The text reproduced below consolidates the different written proposals on raising the specified maximum speed of ALKS up to 130 km/h into a single document. It is based on document UNR157-05-06 (which was derived from the open points list (document UNR157-05-05, column “F”)).

## I. Proposal

Figure 1

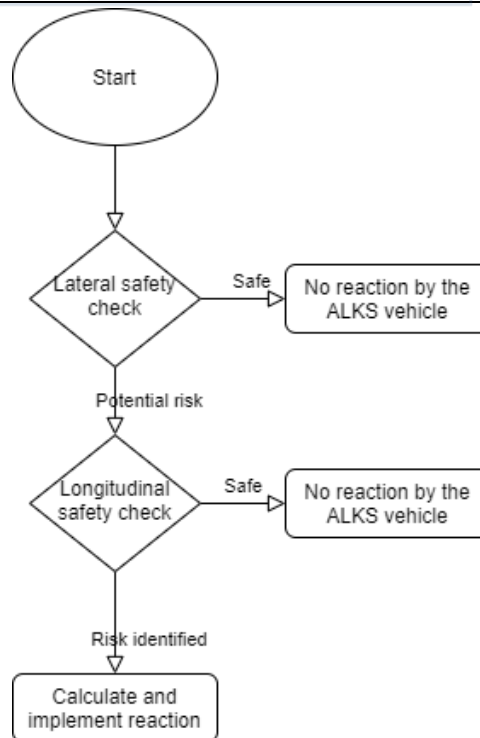
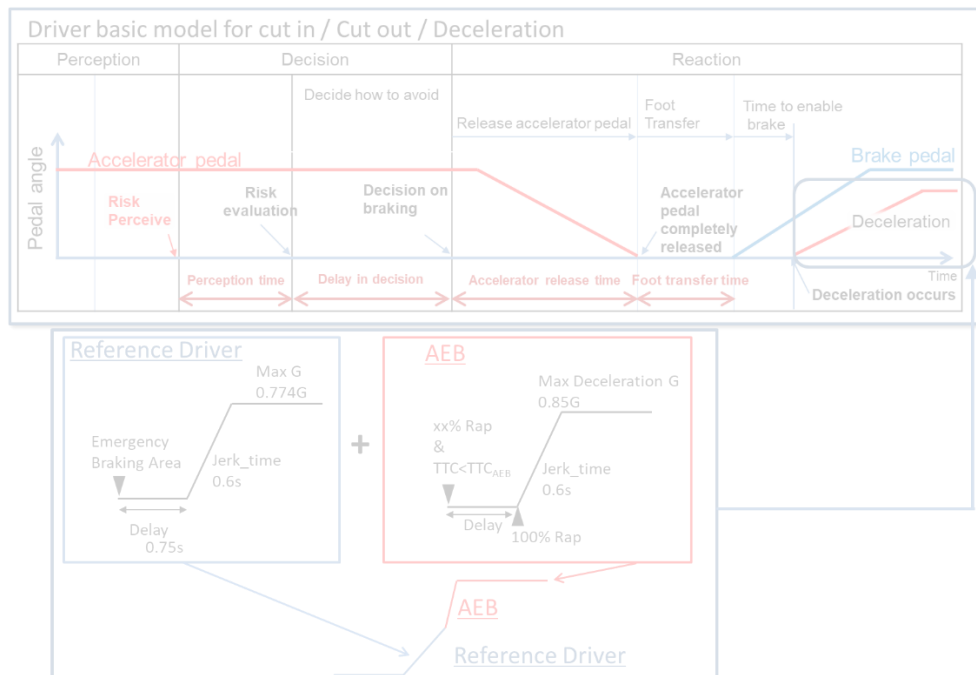
3.2. ~~In a low speed ALKS scenario, the avoidance capability of the driver model is assumed to be only by braking.~~ The driver model is separated into the

following three **steps segments**: "~~Pereception~~ **Lateral Safety Check**"; "**Longitudinal Safety Check Decision**"; and, "Reaction". **A Reaction is implemented only if the Lateral and Longitudinal Safety Checks identify a risk of imminent collision.** The following diagram is a visual representation of these **three steps segments**:

**Flow-chart of the ALKS Skilled-human performance model**

**3.2.1 The Lateral Safety Check identifies a potential risk of collision if the following conditions hold true:**

- a) the rear of the ‘other vehicle’ is ahead of the front of the ALKS vehicle along the longitudinal direction of motion;**
- b) the ‘other vehicle’ is moving towards the ALKS vehicle**
- c) the longitudinal speed of the ALKS vehicle is greater than the longitudinal speed of the ‘other vehicle’**
- d) the following equation is satisfied**
